TECHNICAL BULLETIN

FA-A-0159-F

Changes in the rating plate and the front part of modules according to the compliance with ANSI/ISA-12.12.01

MELSEC-Q series, MELSEC iQ-R series

■Models marked with 55°C

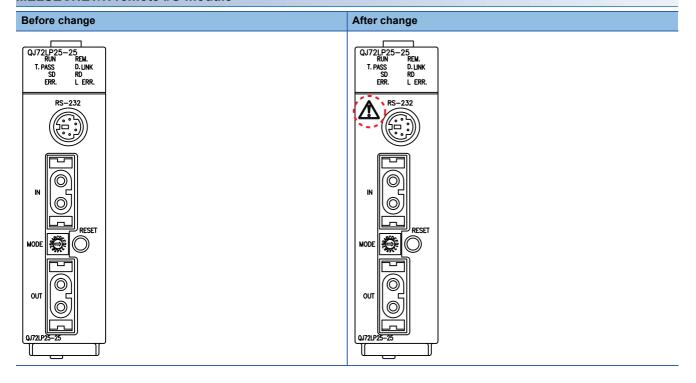
The temperature is marked in the position of 2.

Module	Model
Programmable controller CPU	R04ENCPU, R08ENCPU, R16ENCPU, R32ENCPU, R120ENCPU
Main base unit	R310RB, R312B, R38B, R35B
Extension base unit	R610RB, R612B, R68B, R65B
RQ extension base unit	RQ612B, RQ68B, RQ65B
